LAVALLEE | BRENSINGER ARCHITECTS

ADDENDUM NO. 2

February 26 2016

Re: Sanford High School and Technical Center
12-067-00

SHEET C12 OF C75

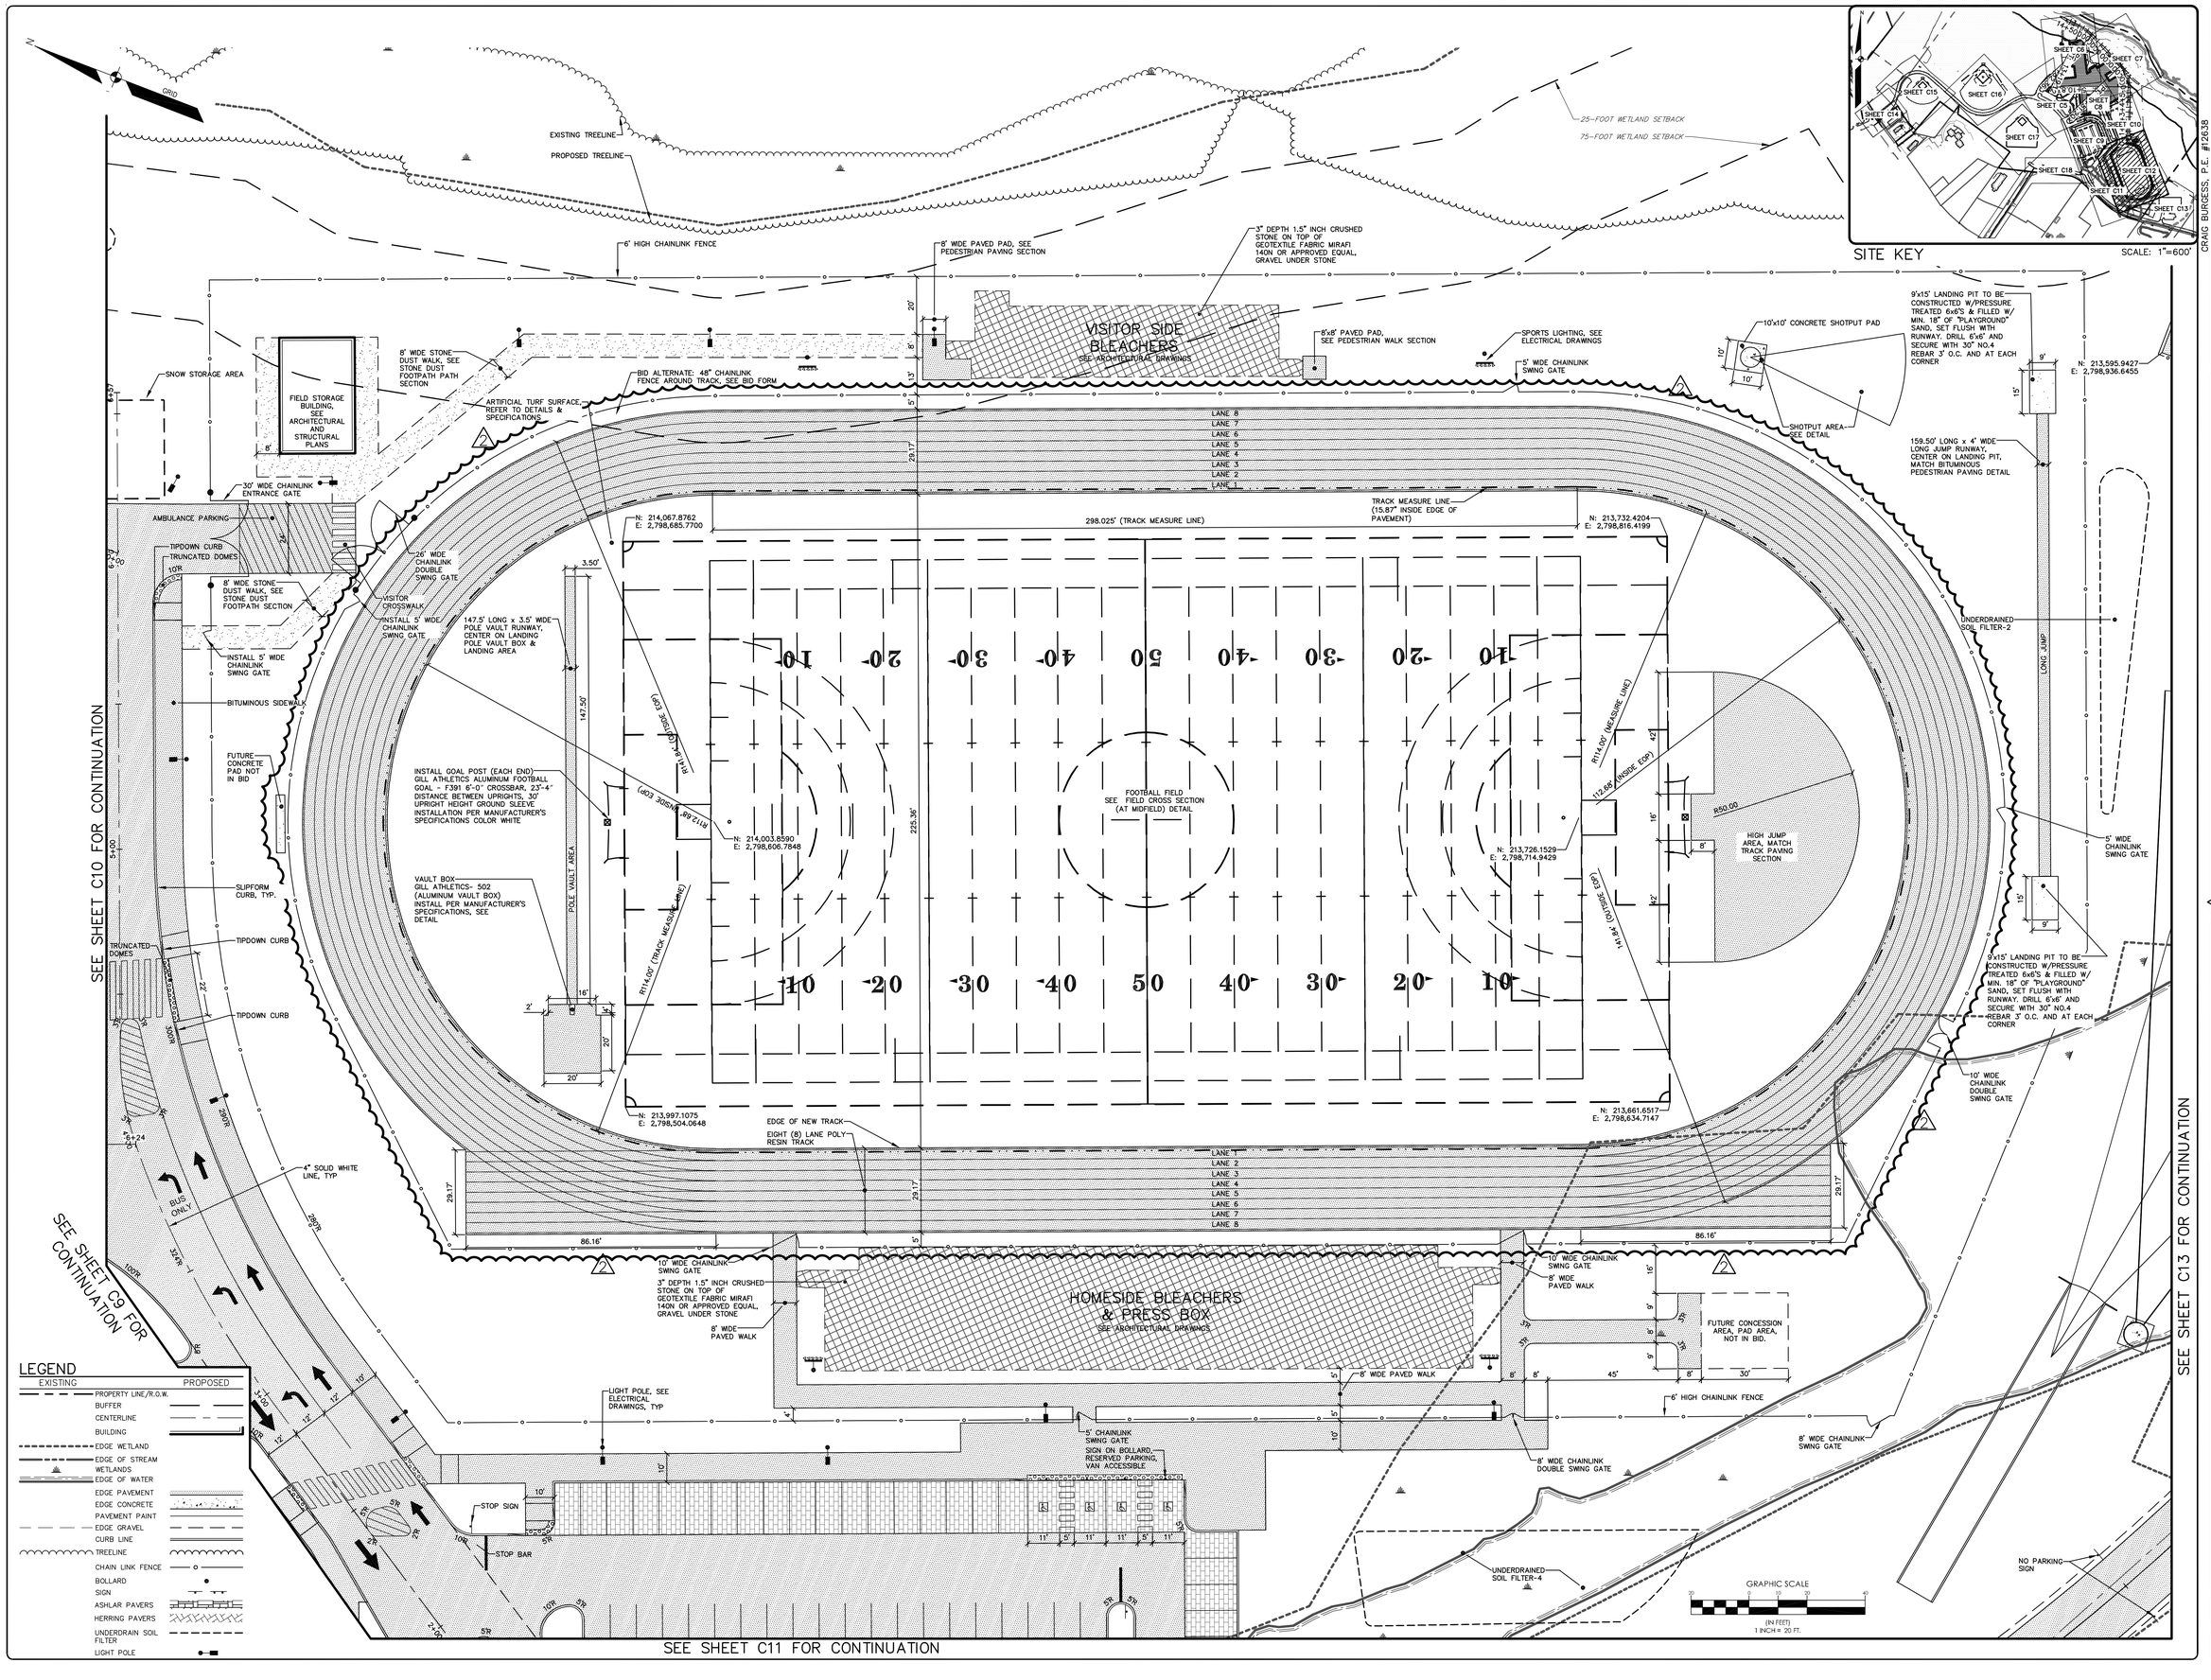
Item No. 2.54 **Reference Civil Drawings 12, 28, 43:** See attached revised drawings for Civil including sheets 12, 28, and 43. Changes include Site Plan Sheet 12: Adjusted track dimensions to meet high school standards. Adjusted dimensions of pole vault landing pad to meeting minimum high school standards, adjusted location of fence and gates at outside edge of track, adjusted location of future concrete pad for scoreboard. Grading Plan Sheet 28: Adjusted spot grades at inside and outside track edge, Adjusted spot grades of pole vault area and landing pad, slightly adjusted location of stilling basin/ level spreader at outlet of 36" pipe to avoid wetland impact. Utility Plan Sheet 43: Adjusted drainage stormdrain and underdrains along inside edge of track, Inverts were revised accordingly at drainage structures, Adjusted interior j-drains to tie into revised underdrain.

1 ENLARGED LEVEL 1 PLAN - AREA C1
1/4" = 1'-0"

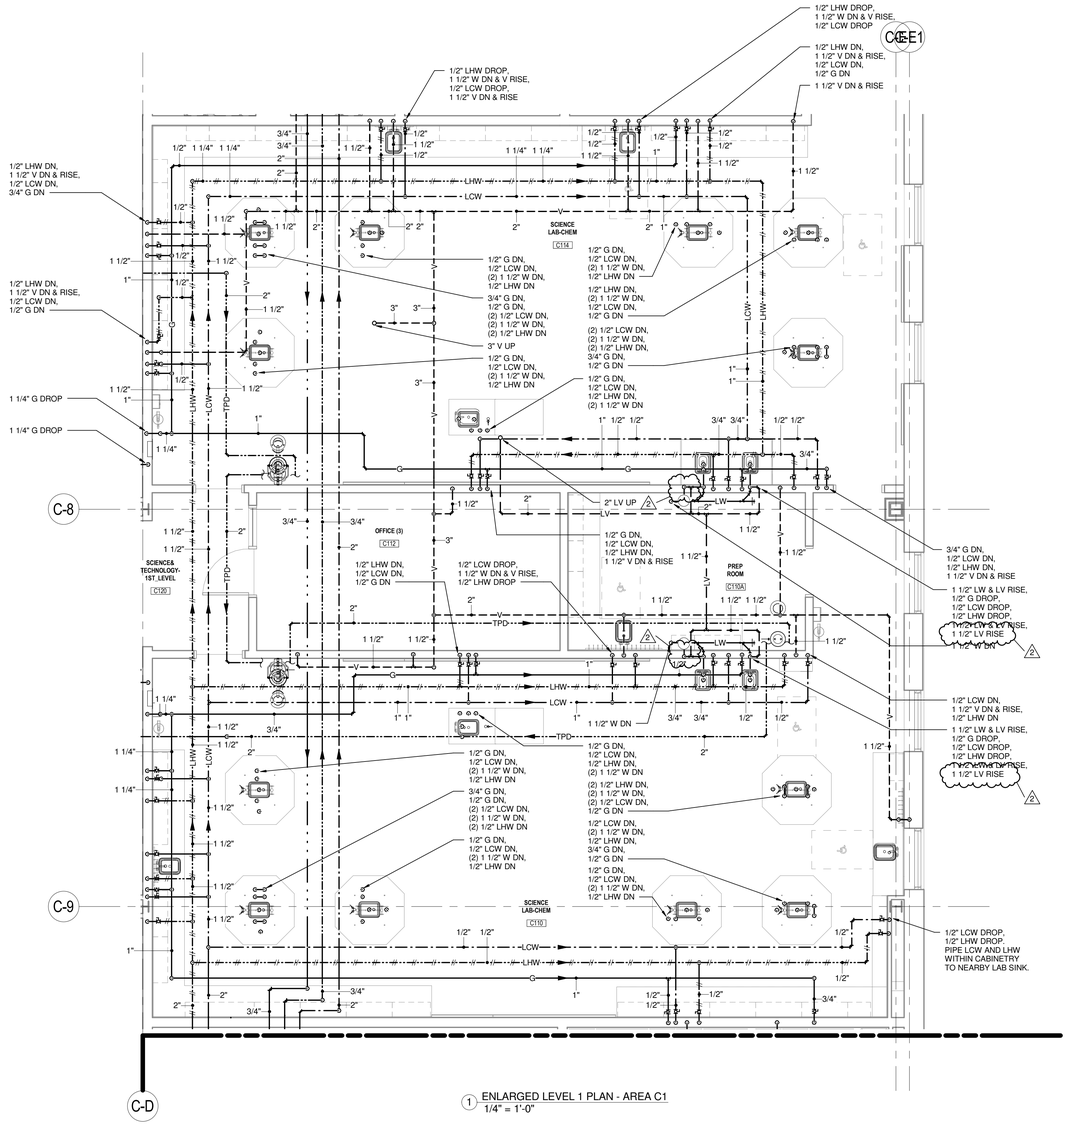
Item No. 2.67 **Reference Plumbing Drawing P2.02 & P5.01:** See attached revised drawings for Plumbing including sheets P2.02 & P5.01
